**Technical Service Bulletin**

**PATIENT MONITORS**

**Subject:** TSB – SPOT LXI RoHS CONVERSION\_LED LCD

**Product(s) Referenced:** All SPOT LXi 4500 devices

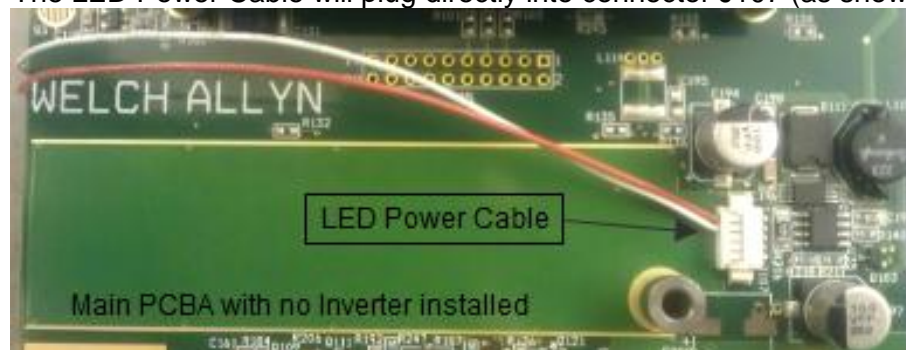
1. The LED Power Cable is routed around the mainboard (as shown):

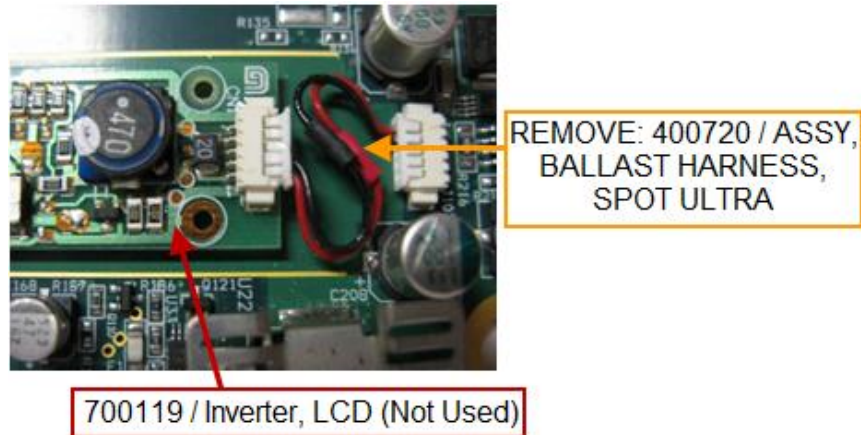
2. The LED Power Cable will plug directly into connector J107 (as shown).

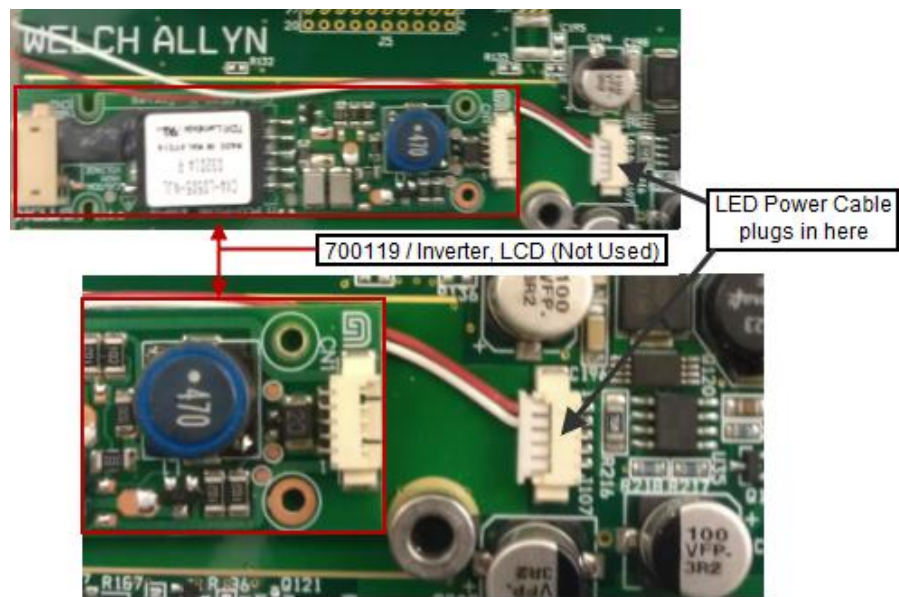
- When replacing the CCFL display (703354) with the LED LCD (720480), remove the Ballast Harness assembly (p/n: 400720) from connector J107 and from the inverter board.

- With the Ballast Harness assembly removed, by-pass the inverter board with the LED Power Cable and plug it directly into connector J107 (as shown).
